Updated 4Tx Pilot Patterns for IEEE 802.16m

IEEE C802.16m-08/0006

To discuss and adopt the proposed text in the revision of the 802.16m SDD

Updated 4Tx Pilot Pattern

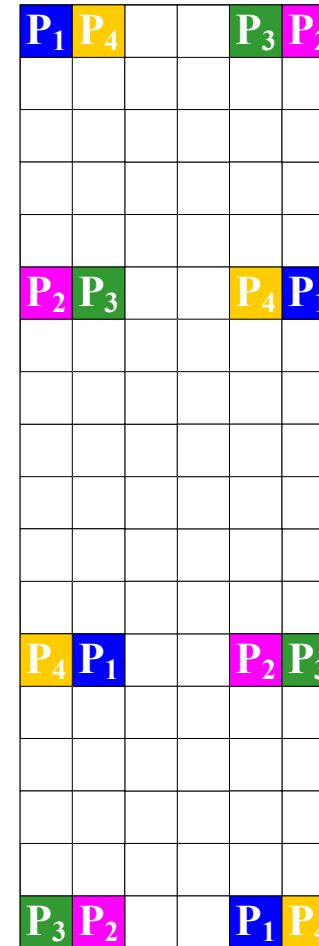
- All 4 pilot streams have mirrored pilot patterns
- Occupy the same set of subcarriers as the original 4Tx pilot pattern
- One sets of MMSE or interpolation weights for all 4 pilots
- Significant complexity reduction

- Section 11.5.3, page 80, line 1
 - Replace figure 42 by the figure in page 4 of contribution C802.16m-08_0006
